Date Received: 08-01-2025
Date Submitted: 08-06-2025

III. RESPONSES

Regarding SDG&E's Pole Clearing Target WMP.512:

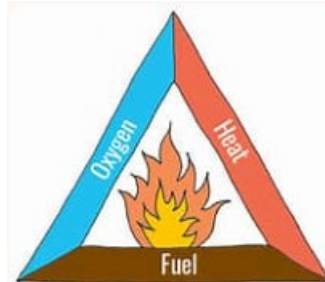
a. How many ignition datapoints are needed to conduct an analysis of the effect of enhanced clearances on the probability of ignition? i. Explain how this number was calculated.

a. SDG&E disagrees with the interpretation, "This approach was used because the number of ignitions in the database is too small to draw robust conclusions." This data request does not include the citation from the White Paper or the third party's assessment. As stated in the White Paper of the enhanced clearance study, the research results demonstrate that greater clearance reduces the probability of outages by a measurable amount. The study evaluates the impact of clearance on causing vegetation-bare conductor contacts and treats every vegetation-bare conductor contact as a heat event. The heat generated by such contact is one of the three factors that contribute to the probability of fire, as shown in the fire triangle figure.

Because the purpose of the study is to evaluate the effectiveness of tree trimming clearance, measuring and modeling probability of vegetation contact is the correct method, whereas probability of ignition is not. Modeling probability of vegetation contact is equivalent to modeling probability of heat events caused by vegetation contact. When holding the other two factors (Oxygen and Fuel) consistent, a reduction in probability of heat event is a reduction in probability
